Riverfront Phase IIB Fort Wayne, IN

ADDENDUM #1

October 7, 2024

ADDENDUM NO. 1

C606 1818

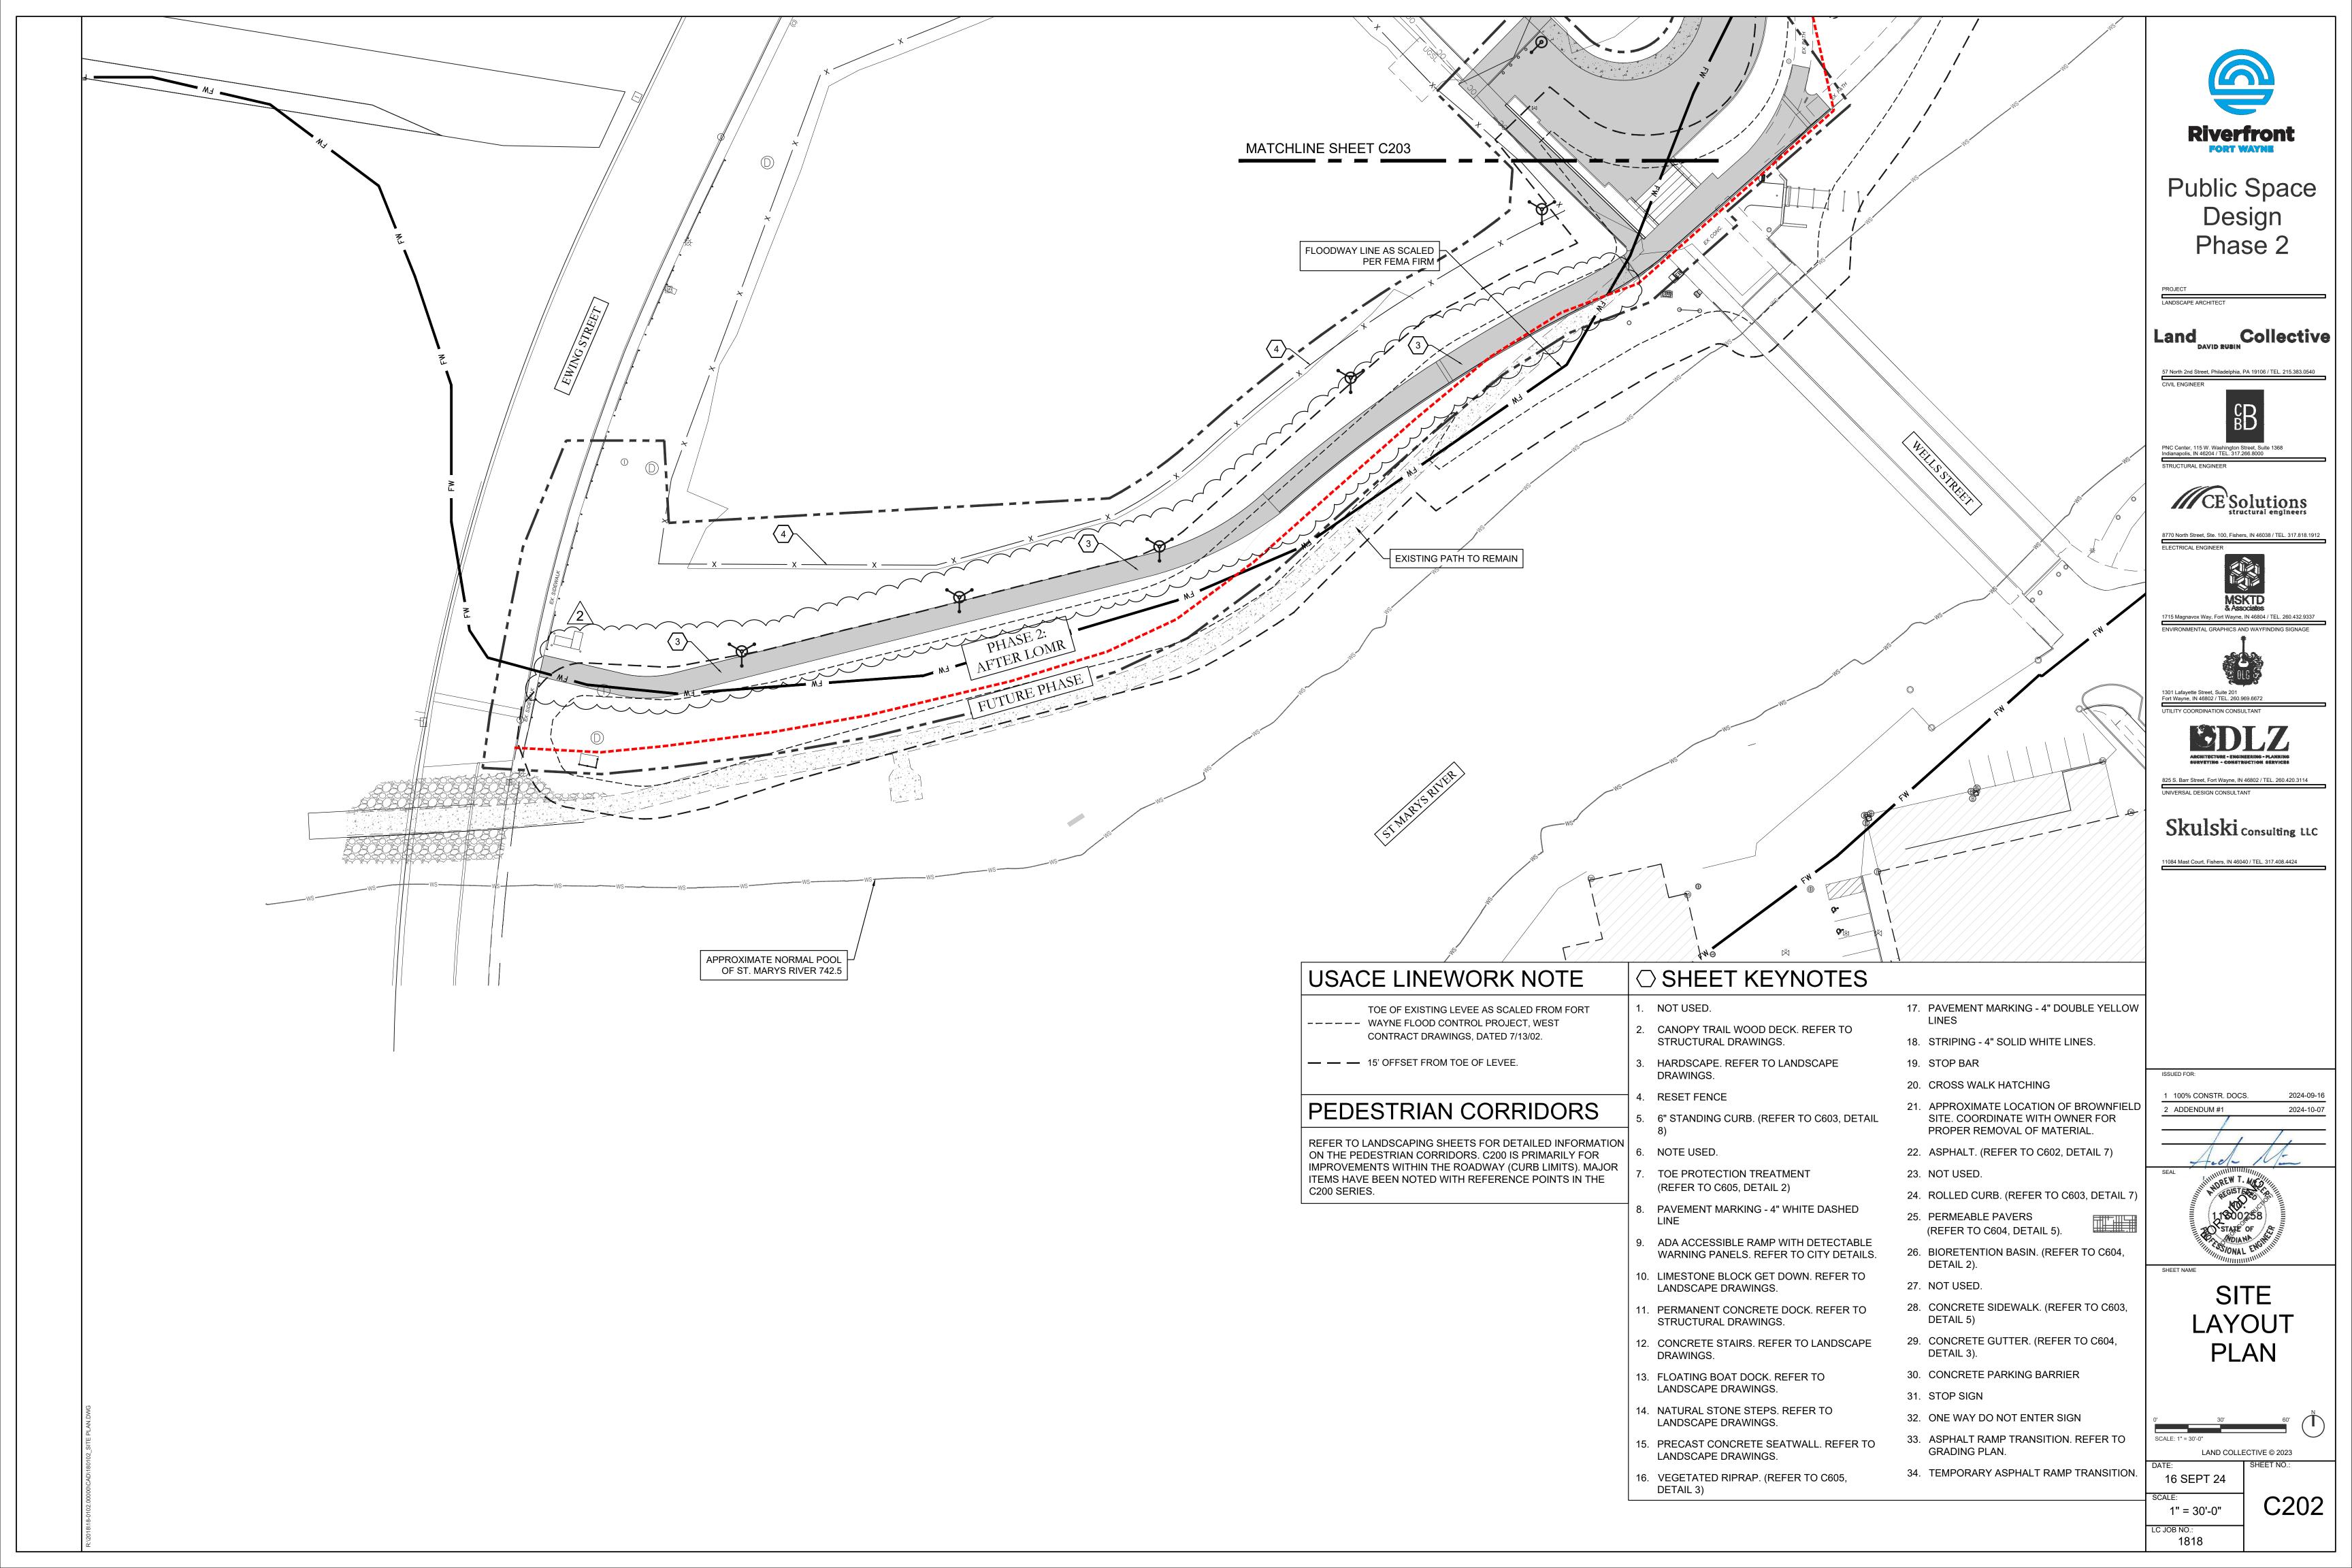
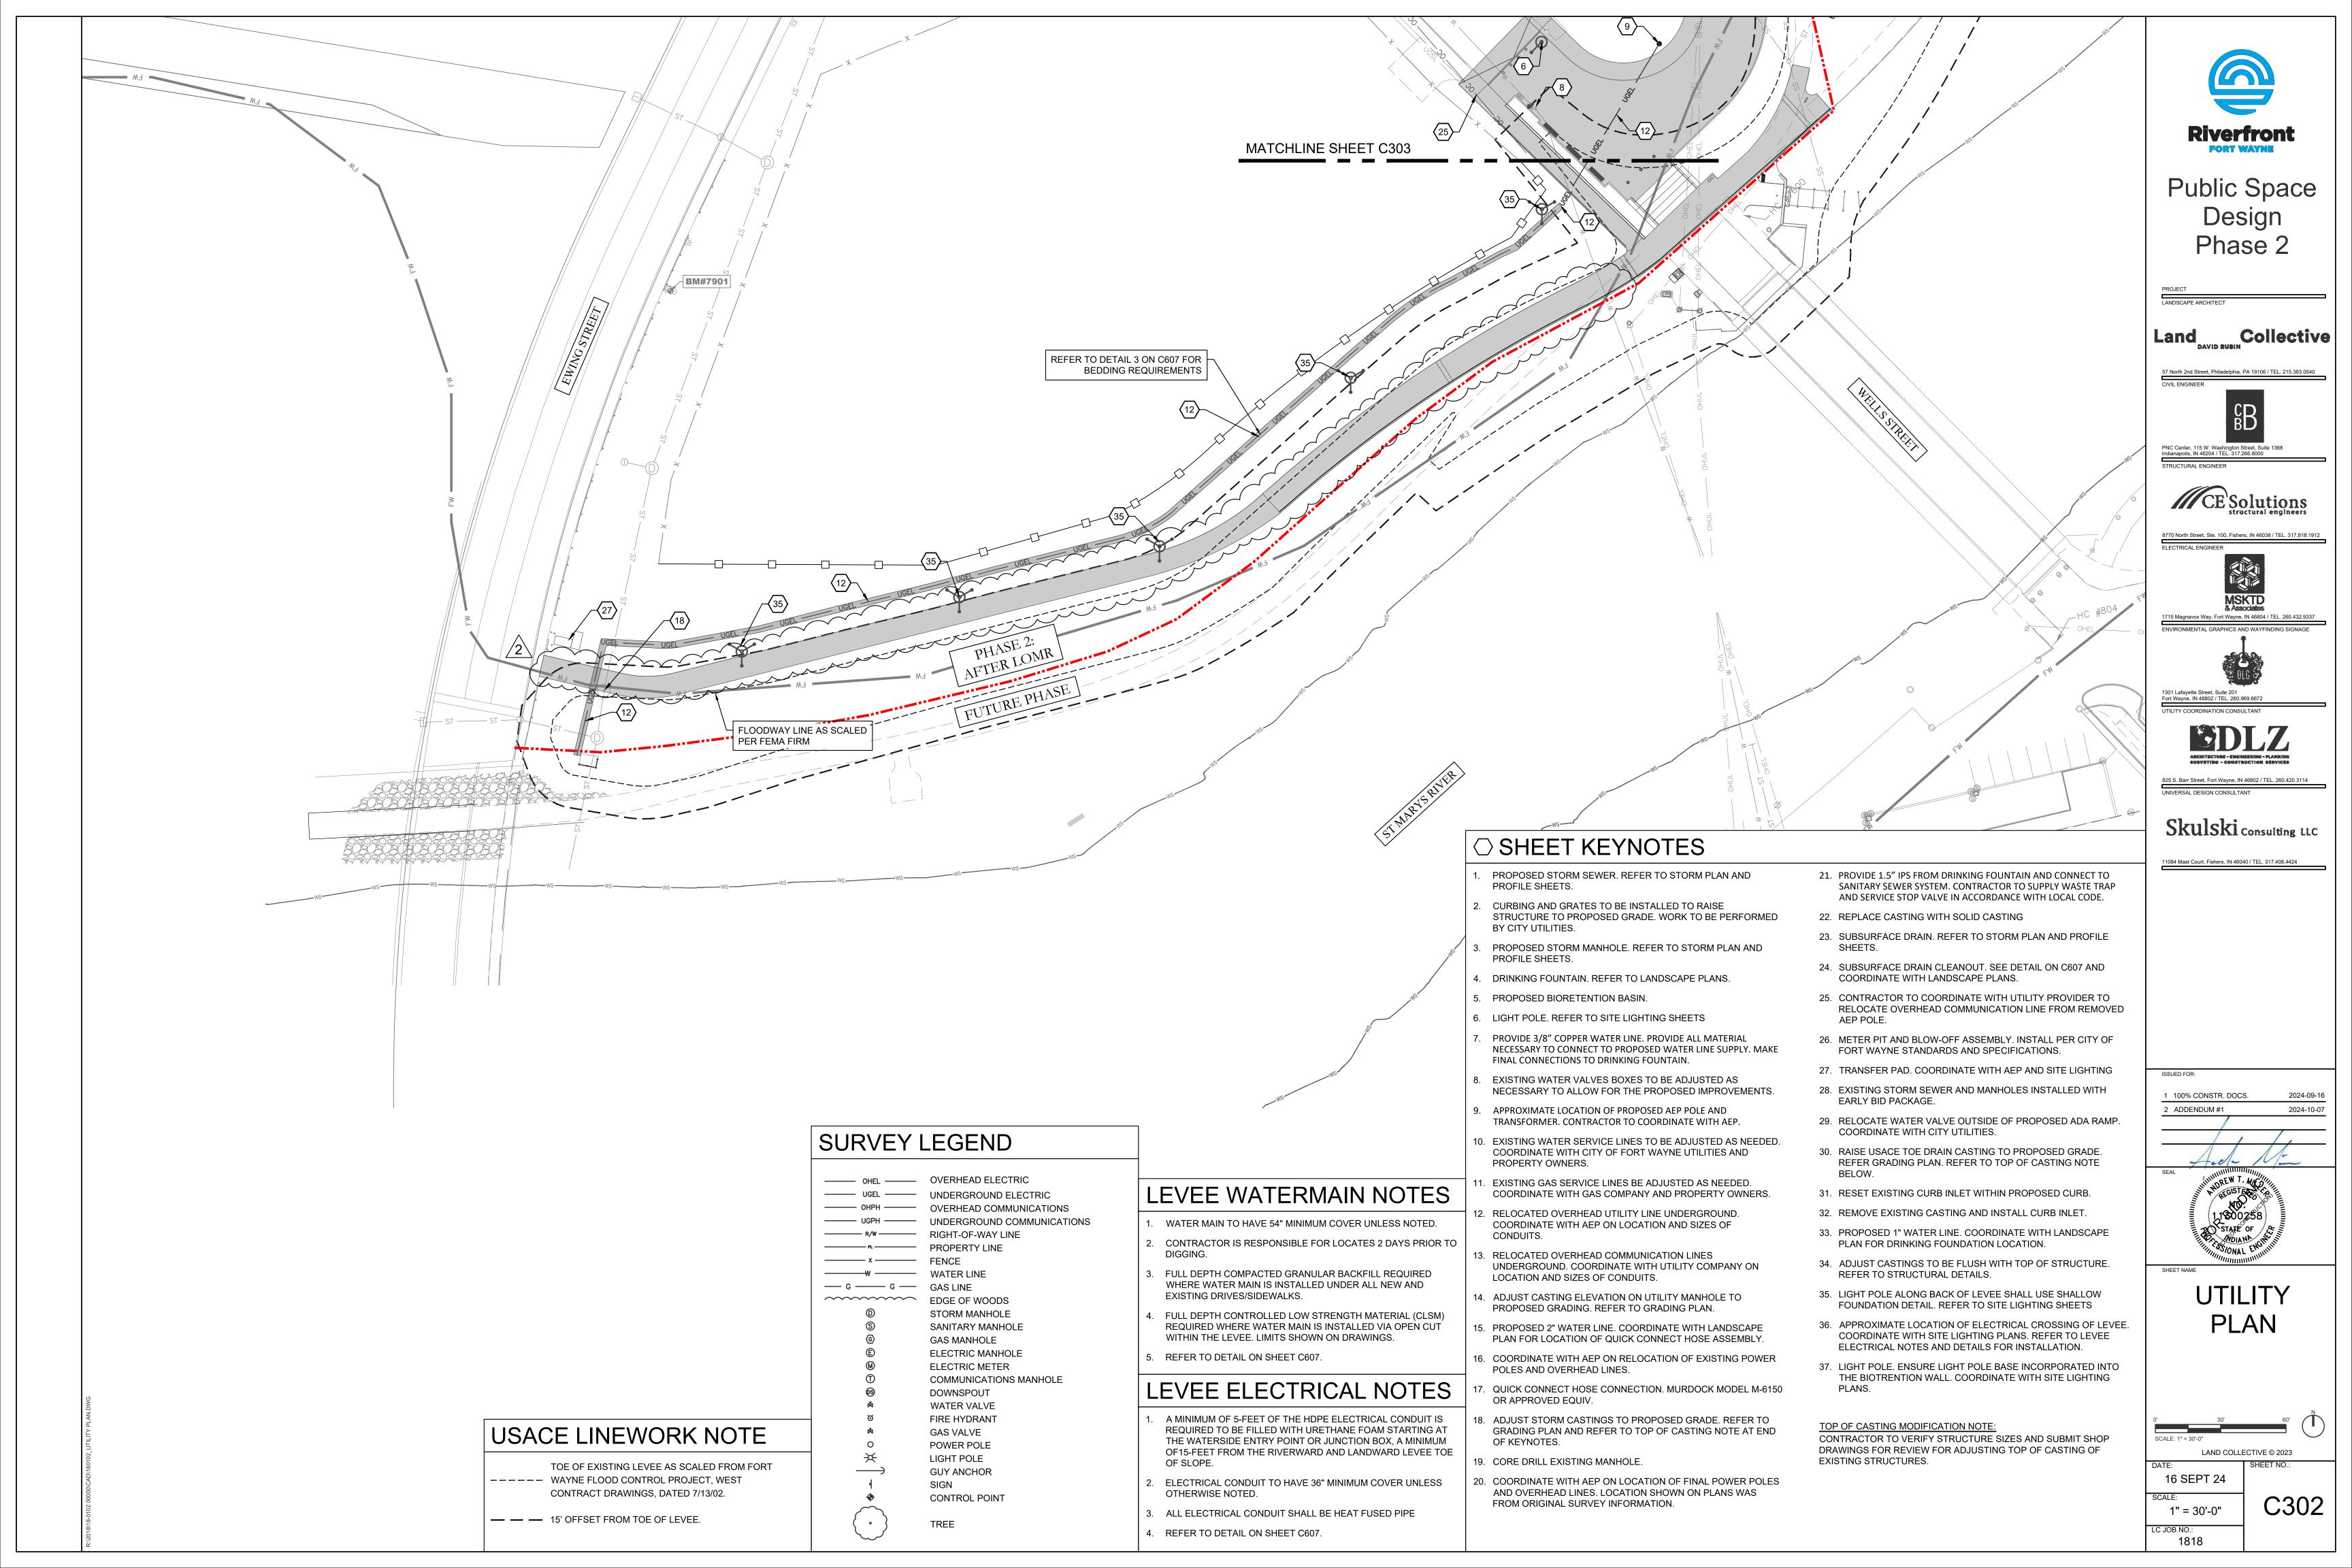
C606 - Miscellaneous Details

- Added Detail #2 Removable Bollard
- Added Detail #3 Trail Connection at Ewing Street
